CERTIFICATE OF APPROPRIATENESS

Applicant: Phuong Nguyen, agent, for Margaret Shaheen, owner

Property: Lot 20, Block 250, Houston Heights South Neighborhood Subdivision. The property includes an historic 1,064 sq ft, one-story wood single-family residence situated on a 6,600 square foot (50' x 132') interior lot.

Proposal: Rear Addition

Side Setbacks (Addition and New Construction)

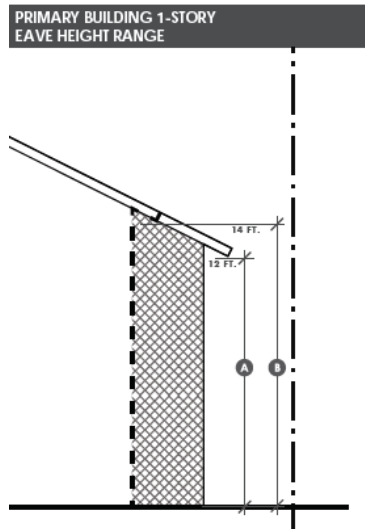
Proposed North side setback (1): 5 ft.

Proposed South side setback (2): 25 ft. 6 inches

Cumulative side setback: 30 ft. 6 inches

Eave Height (Addition and New Construction)

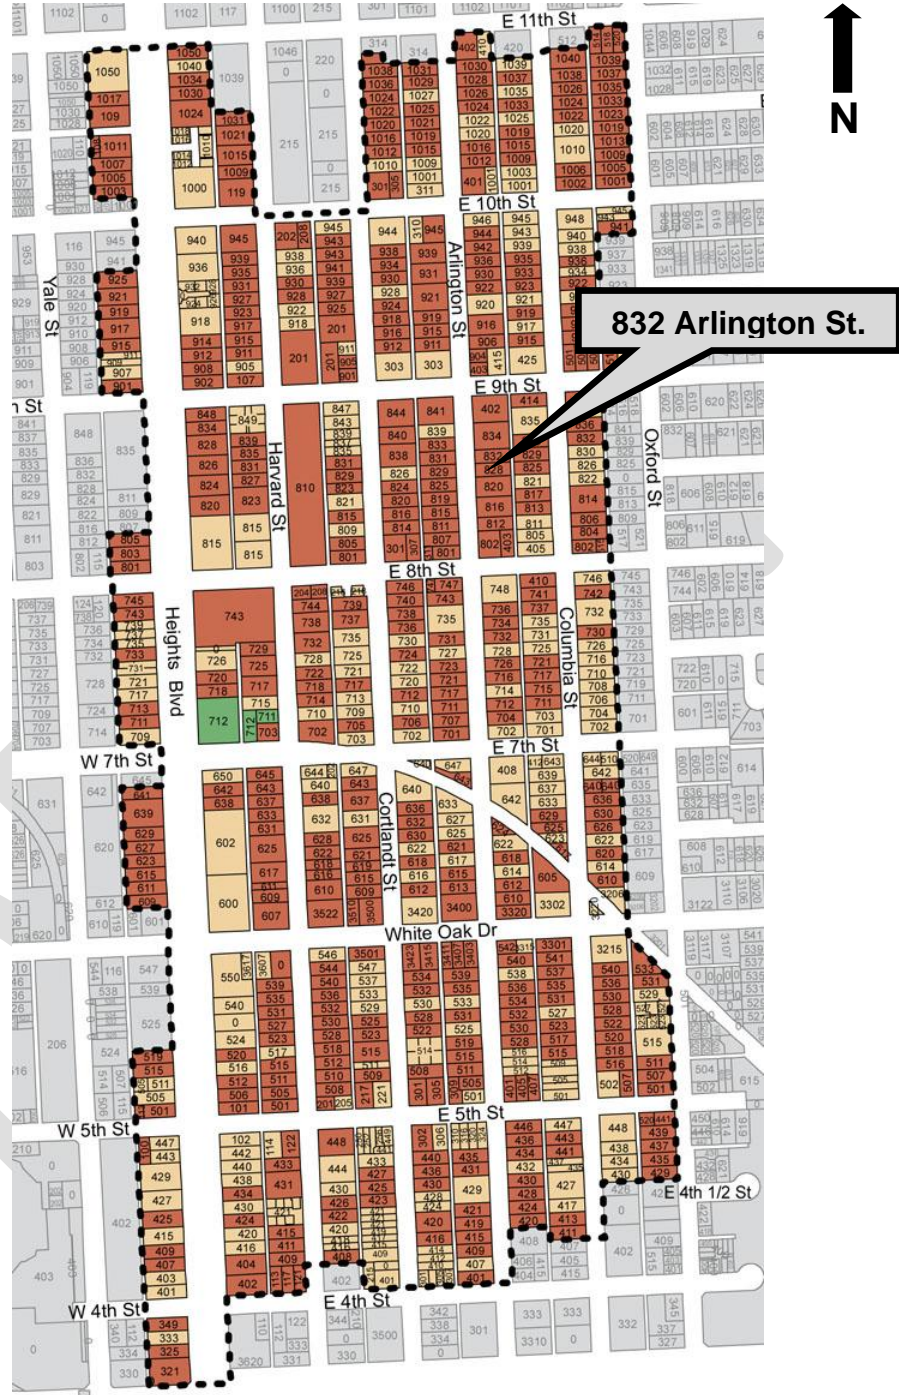
Heights Design Guidelines Section 5-16: Plate heights for additions should appear to be the same or lower than those of the existing house.

Proposed eave height: 19 ft. 4 1/4 inches

Jeldwen W-5500™ Clad-Wood
Window: Double-Hung

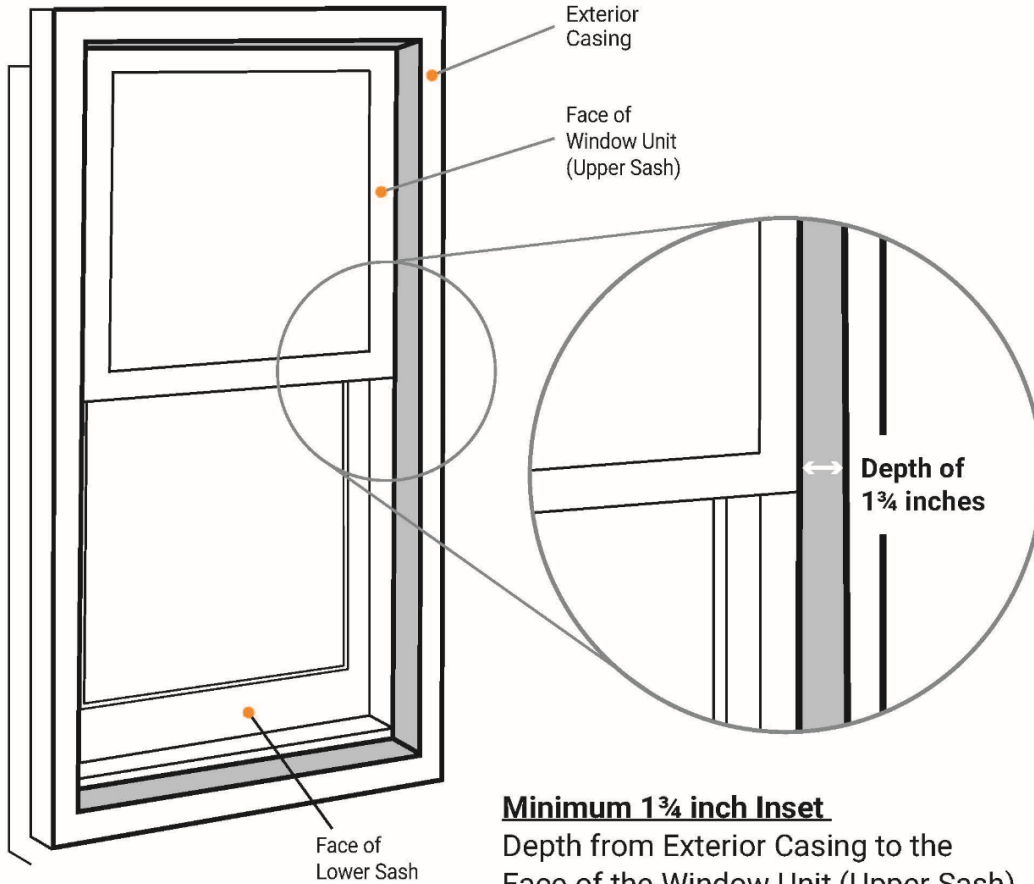
ALL NEW WINDOWS MUST BE INSET 1¾ Inches – See Attachment 1
Double-Hung Windows Must Be Equally Horizontally Divided 1-over-1
ALL CEMENTITIOUS BOARD MUST BE SMOOTH

Minimum 1 3/4 inch Inset

Windows must be 1-over-1
(equally horizontally divided)
